**FINAL PRODUCT/PROCESS CHANGE NOTIFICATION #16885**Generic Copy

**Issue Date:** 27-Jul-2012**TITLE:** Qualification of Good-Ark Electronics for SMA/SMB Power Rectifier Products**PROPOSED FIRST SHIP DATE:** 27-Oct-2012**AFFECTED CHANGE CATEGORY(S):** Power Discrete Division (PDD) of the Standard Product Group**FOR ANY QUESTIONS CONCERNING THIS NOTIFICATION:**

SMA

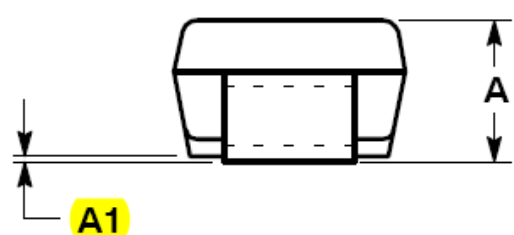
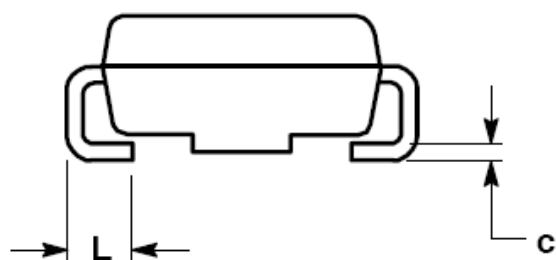
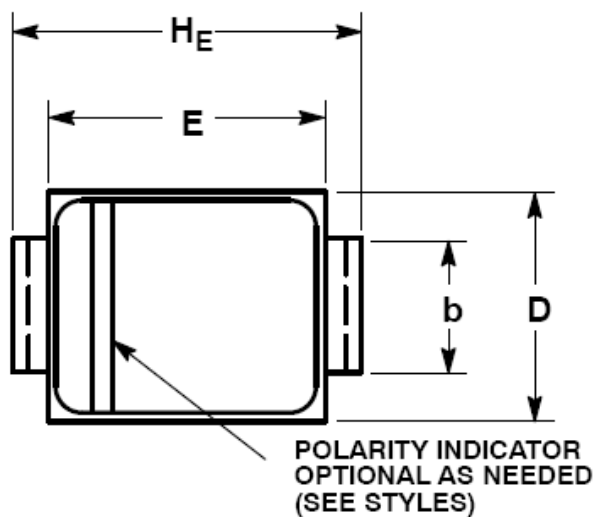
NEW CASE OUTLINE DIMENSIONS:

DIM	MILLIMETERS			INCHES		
	MIN	NOM	MAX	MIN	NOM	MAX
A	1.97	2.10	2.20	0.078	0.083	0.087
A1	0.05	0.10	0.20	0.002	0.004	0.008
b	1.27	1.45	1.63	0.050	0.057	0.064
c	0.15	0.28	0.41	0.006	0.011	0.016
D	2.29	2.60	2.92	0.090	0.103	0.115
E	4.06	4.32	4.57	0.160	0.170	0.180
H <sub>E</sub>	4.83	5.21	5.59	0.190	0.205	0.220
L	0.76	1.14	1.52	0.030	0.045	0.060
